Re: 300 Water Street  
City of Guelph

In response to the comments received from the City of Guelph (dated March 1, 2019 and March 5, 2019), we offer the following responses for your review and consideration:

**Hydrogeological Study (dated March 1, 2019)**

Re: Groundwater Level Monitoring Summary -  
Hydrogeological Study, 300 Water Street,  
Guelph, ON

**Figure 1: Groundwater Levels Recorded at MW-01.** Solid line represents datalogger data. Triangle marks represent manual readings.

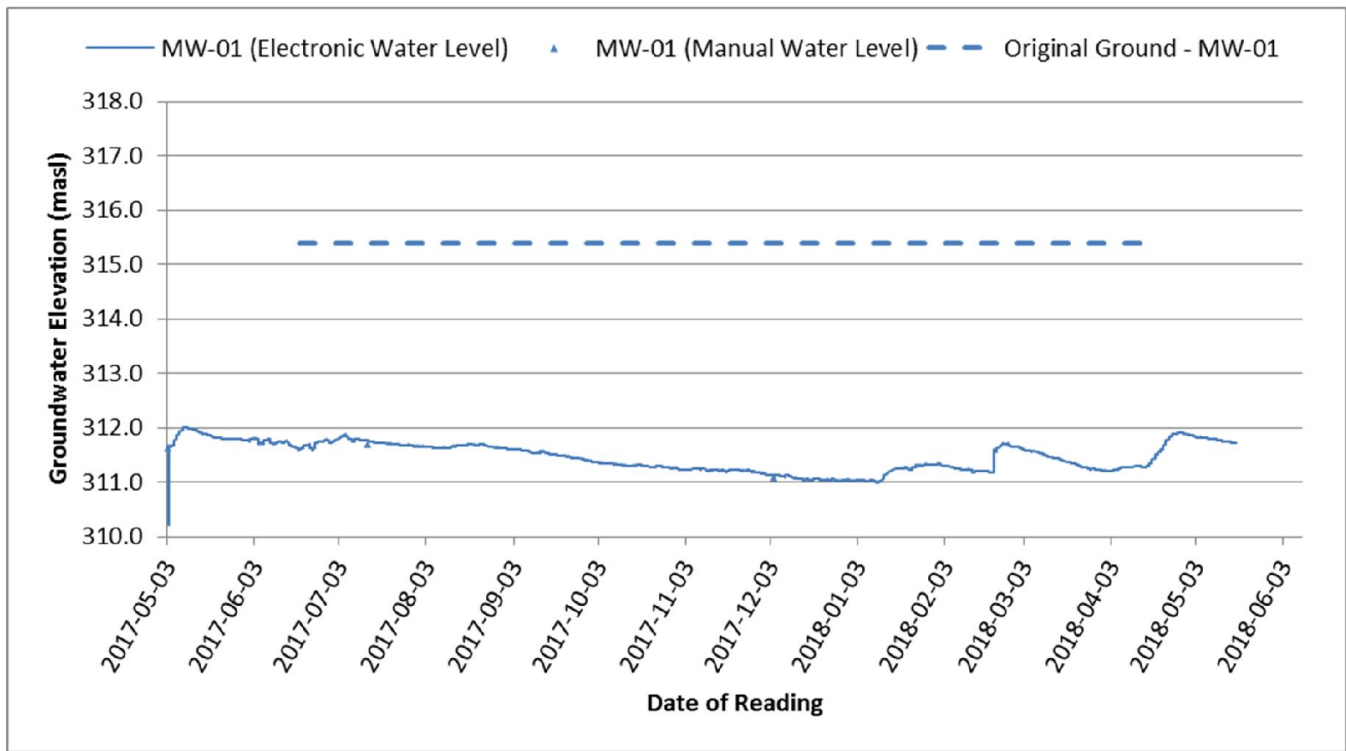
**Comment 3:** Hydrographs were not included in the report. This item should include a minimum of one year's worth of data showing groundwater levels that characterize seasonal highs, spring freshet and other storm and melt events with comparison to local precipitation data, per the City of Guelph Guidelines for the Preparation of Environmental Impact Studies (2017).

**Comment 4:** It appears that water levels from MW-01 may be unreliable to characterize seasonal water level fluctuation due to the well construction. Well screens that straddle multiple stratigraphic units will yield a blended head measurement and not a water level indicative of the glaciofluvial sand and gravel unit. In addition, water levels were collected shortly after drilling, and there is no indication that the well was developed prior to the measurement of water levels or collection of a water quality sample. Please clarify.

**Response:** *Acknowledged. A copy of the letter documenting the groundwater level measurements at the site, along with the seasonal high groundwater level has been enclosed.*

**Response:** *Acknowledged. A record of groundwater level data spanning 12 consecutive months has been provided. The well was developed at the time of sampling using Waterra tube to pump the well. Therefore, the well was developed in advance of the period of long-term monitoring. Due to the low hydraulic conductivity of the weathered bedrock (i.e. due to its pulverized consistency and the presence of silt-clay seams has significantly lower hydraulic conductivity than the sand and gravel), the straddling has no significant effect on the accuracy of the groundwater levels at MW-01.*
